APPLICATION NO.	FILING DATE	FIRST NAMED INVENTOR	ATTORNEY DOCKET NO.	CONFIRMATION NO.
10/554,216	10/24/2005	Morihiro Murata	SON-3205	8271
	7590 07/31/200 IAN & GRAUER PL I	EXAMINER		
LION BUILDI		PRANGE, SHARON M		
1233 20TH STREET N.W., SUITE 501 WASHINGTON, DC 20036			ART UNIT	PAPER NUMBER
			3728	
		MAIL DATE	DELIVERY MODE	
		07/31/2008	PAPER

DETAILED ACTION

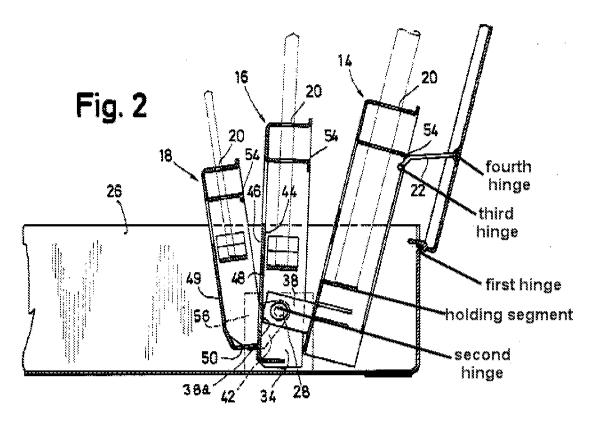
Regarding claim 1, Sautter discloses a storage case with: a case body (member 10), a case cover (lid member 12), a supporting plate (tray 14) with a holding segment (see Fig. 2) for holding a portion of the object to be stored, the holding segment disposed at a base end of the supporting plate, the object being inserted into and taken out from the holding segment at a free end of the supporting plate or tray; and a four link

mechanism with a first hinge pivotally supporting the case body and the case cover in an openable/closeable manner (column 2, lines 41-44; see Fig. 2), a second hinge via which the base end of the supporting plate is pivotally supported by the case body in a n openable/closeable manner such that the holding segment faces the case body (column 2, lines 58-67; Fig. 2), and a third hinge and a fourth hinge via which opposite ends of an arm segment (connecting means 22) disposed between the supporting plate and the case cover are pivotally supported by the supporting plate and the case cover in an openable/closeable manner such that, upon opening or closing the case cover relative to the case body, the supporting plate and the case cover move simultaneously with each other (column 2, lines 53-57; column 2, lines 67-68, column 3, lines 1-3; Fig. 2), wherein when the case cover is being closed over the case body in a state in which said at least one portion of the object to be stored is held by the holding segment of the supporting plate, the object to be stored is rotated so as to be positioned below the supporting plate (Fig. 3), whereby the object to be stored and the supporting plate become stored in a storing position of the case body, and wherein when the case cover is being opened from the case body, the stored object is rotated so as to be positioned above the supporting plate, whereby the stored object and the supporting plate are drawn out from the case body (Fig. 3).

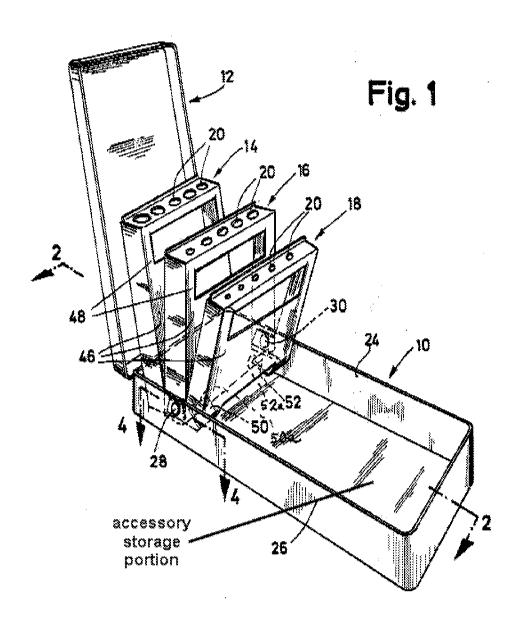
Regarding claim 6, the case body is provided with an accessory storage portion.

The bottom of the case body is capable of storing an accessory in the form of a booklet or instruction manual (Fig. 1).
